Office Action Summary

10/816,697

DETAILED ACTION

6. Claims 19-24, 26, and 30-35 are rejected under 35 U.S.C. 102(b) as being anticipated by Donelson et al (US 6492053).

FIG. 1

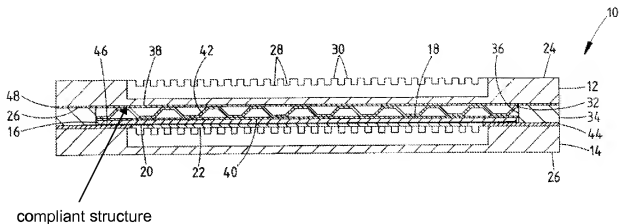
Regarding claim 19, the Donelson reference discloses a fuel cell stack comprising: a plurality of planar fuel cell "16" that inherently comprises a first fuel cell assembly and a second fuel cell assembly electrically coupled together such that sealed manifolds extend between the first and second fuel cell assemblies, each fuel cell assembly comprising: a hollow manifold comprising a top wall "34" & "42" and a bottom wall "14", wherein the hollow manifold includes a fuel gas inlet manifold "54" (sealed fuel passage) and a fuel gas outlet manifold "56" (sealed fuel passage) for allowing fuel to enter and exit the hollow manifold; and a fuel cell "16" comprising an anode "18", a cathode "22", and an electrolyte "20" disposed there between, wherein a portion of the top wall "34" of the top wall forms a side wall in direct contact with the fuel cell such that the fuel cell is coplanar with the hollow manifold and wherein a portion of the top wall "42" extending between the fuel cell and the sealed fuel passage forms a compliant structure that is capable of accommodating thermal expansion of the fuel cell in the same plane as the hollow manifold (See Figures 1 and 2 and column 5, line 45 to column 59).

Regarding claim 20, it also discloses a cathode flow channel "28" coupled to the hollow manifold of the first fuel cell assembly and the second fuel cell assembly that is configured for directing an oxidant between the first fuel cell assembly and the second fuel cell assembly (See Figure 1, and column 8, lines 9-10).

Regarding claim 34, it also discloses a compliant structure "42" that is located adjacent to the fuel cell and the sealed passage (See Figure 1).

Regarding claim 35, it also discloses a compliant structure "42" that comprises a corrugated structure (See Figure 1).
